**Amendments to the Drawings:**

**Request for Reconsideration:**

Appl'n No. 10/053,582  
Amd't Dated Mar. 9, 2005  
Reply to Office Action of Dec. 9, 2004  
Annotated Sheet Showing Changes

Fig. 3

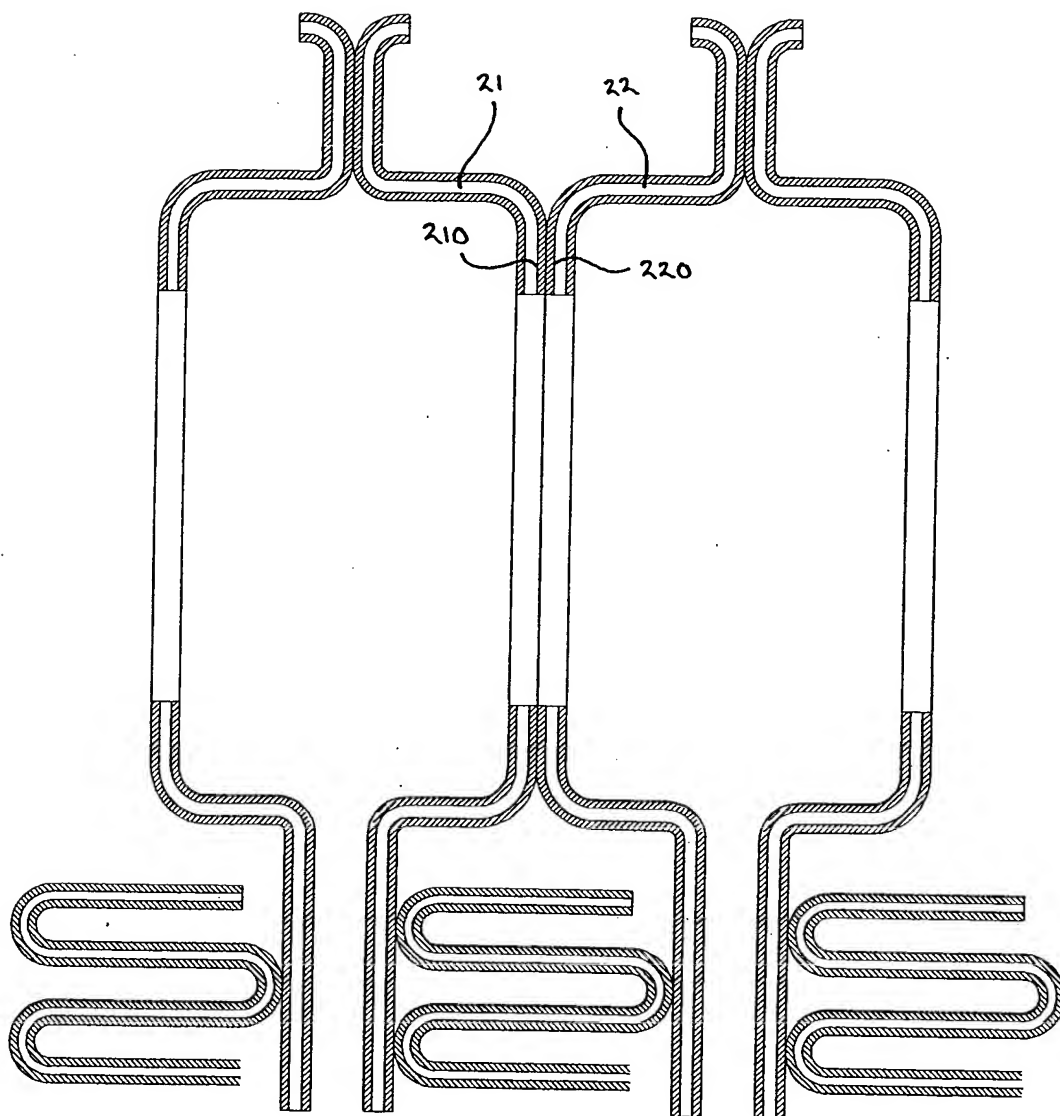
The attached sheet of drawings relabels the “**Fig. 2,**” which was submitted in the Responsive Amendment filed August 10, 2004, as **Fig. 3**. The “**Fig. 2**” submitted on August 10, 2004, was improperly labeled because a **Fig. 2** had been submitted previously. This sheet, which includes relabeled **Fig. 3**, replaces the previously submitted sheet including improperly labeled “**Fig. 2.**”

← RENUMBER  
FIG. 2 SUBMITTED  
08/10/04, AS FIG. 3
